PLANNING AND ZONING BOARD

Being held at Thursday, December 05, 2019
Jarvis Hall 4505 N. Ocean Drive 33308

- 5.a Case Number 2018-L2-SPM-07: Level 2 Site Plan Modification to replace the existing swimming pool with a new rectangular shaped 5'-0" (five foot) depth swimming pool, replace an existing water feature, provide a new covered walkway in Building 3, provide a new covered walkway in Building 4, replace existing hardscaping and concrete pathways, construct new hardscape/landscaping throughout the property, relocate existing trees on site, construct a new volleyball court, construct new fencing along the east side of the property and complete interior renovations.

- 5.b Case Number 2019-L2-SPM-01: Level 2 Site Plan Modification for 100 Commercial Blvd to add one (1) 500 sq. ft. (square foot) interior mezzanine to the existing one (1) story building.

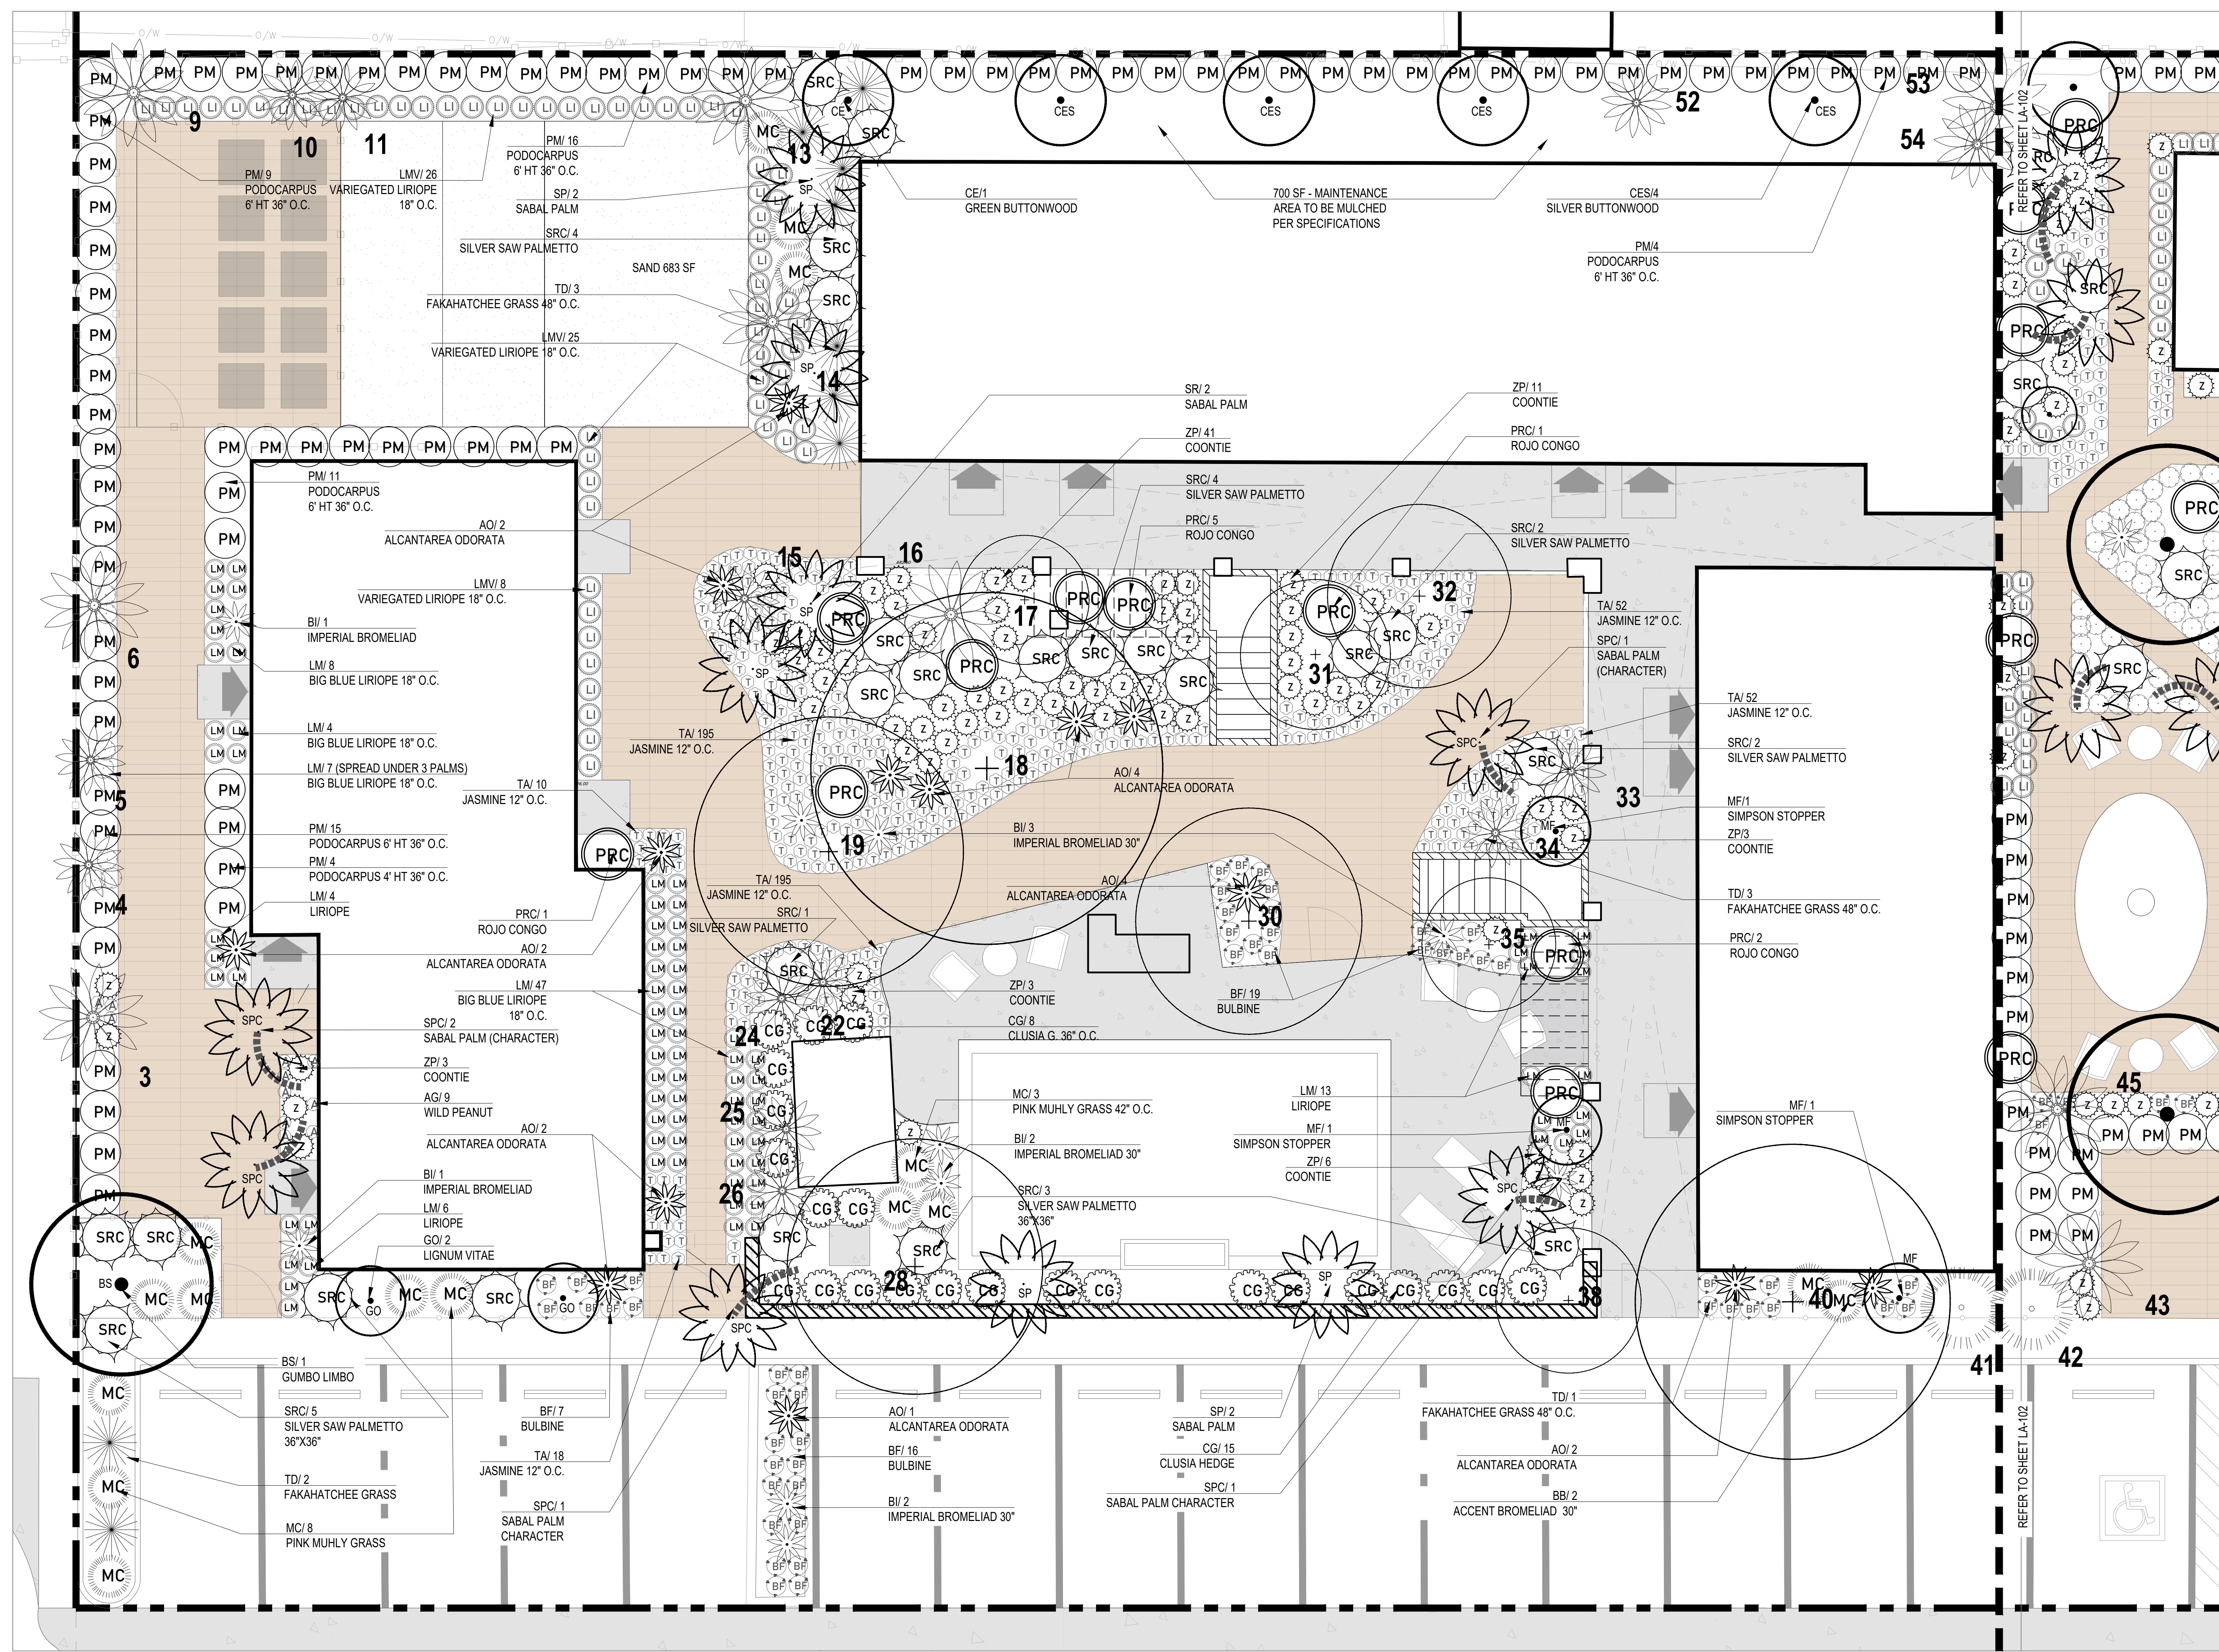
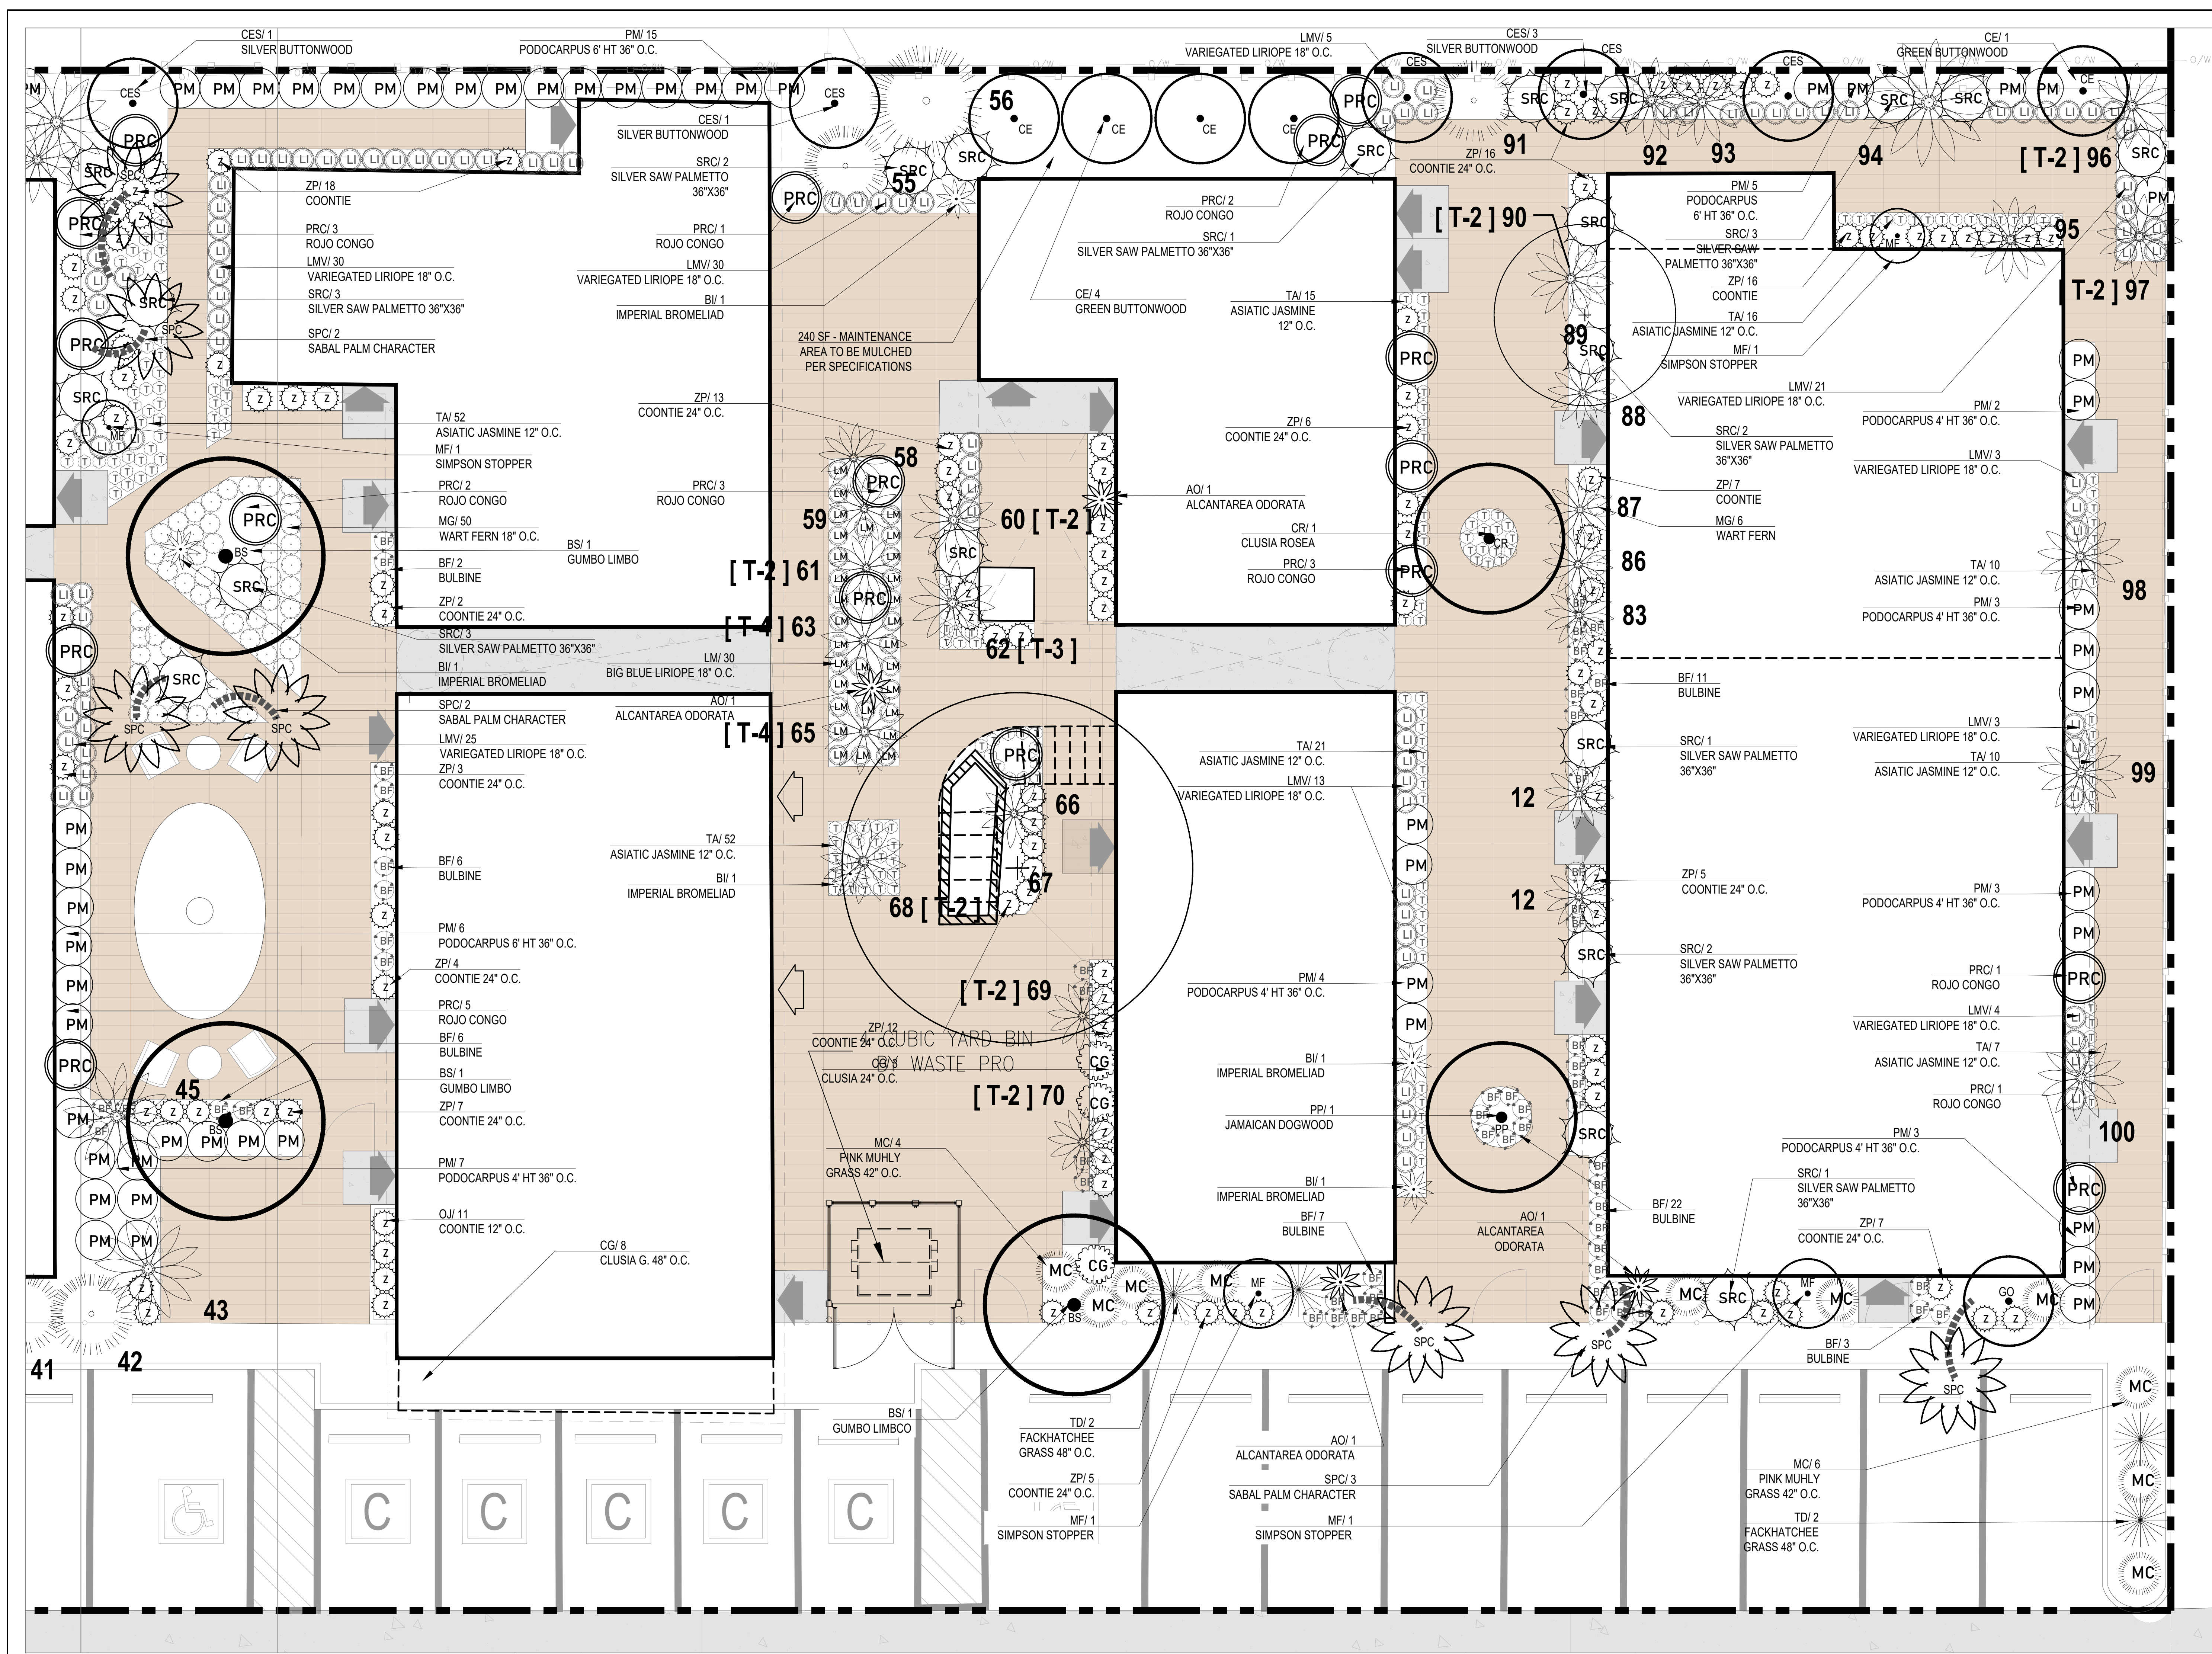
1. Sheets LA-100 and LA-102 should be corrected to remove the trash area shown between Buildings 3 and 4.
